Service Bulletin

Bulletin No.: 22-NA-029

Subject: Poorly Fitted Tonneau Cover at the Front Edge of the Box Exposing Trim that Should be Covered

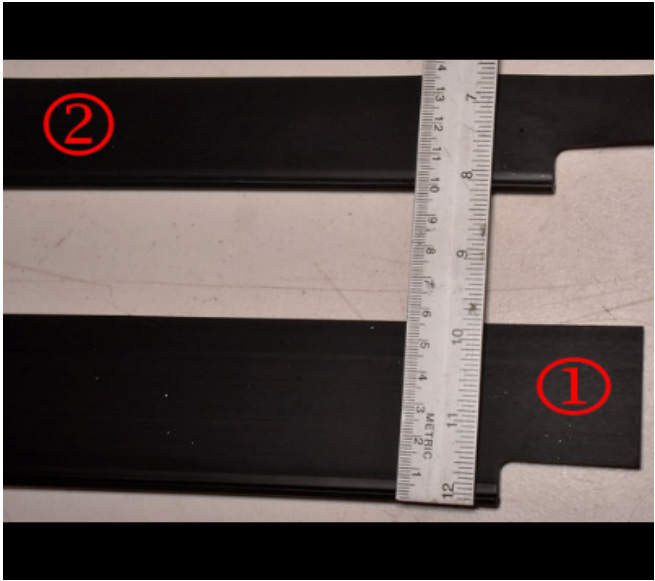
Involved Region or Country	North America, Australia, New Zealand
Additional Options (RPOs)	Equipped with ACCESSORY-TONNEAU - RR COMPT - VINYL W/ INTEGRAL CROSSBOW SUPPORTS (RPO VPB)
Condition	Some customers may comment on their poorly fitted tonneau cover at the front edge of the box exposing the trim that should be covered.
Cause	This condition may be due to the tonneau cover becomes too tight and pulls the front rail rearward when the tonneau cover is closed exposing the trim, as shown in the video above.
Correction	<div style="text-align: center;">  </div> <p style="text-align: right; font-size: small;">5956093</p> <p>Install the revised seal (1) that is 19 mm wider than the current seal (2), as shown in the picture above.</p>

Remove the tonneau and install the revised seal and reinstall the cover. Refer to *Pickup Box Folding Top Cover Package Installation* in SI.
